Philips Medical Systems

FIELD CHANGE ORDER

OPTIMUS 50 / 65 / 80

Tomo program selection not possible.

figure 1

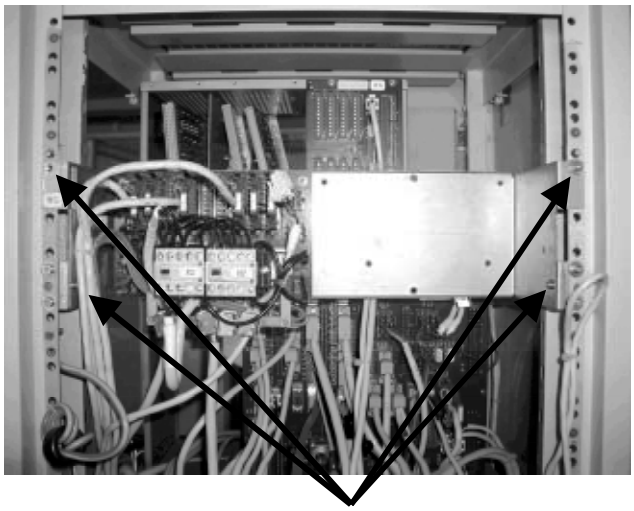
1. Switch the generator OFF.
2. Remove the WA (102) adapter PCB.
3. Pull the generator from the wall to get access to the back panel.
4. Disconnect all cables from back panel WA.
5. Remove, respectively, loosen the screws of the WG adapter (figure 1).
   Turn the adapter in vertical position to get easy access to the option rack PCB.
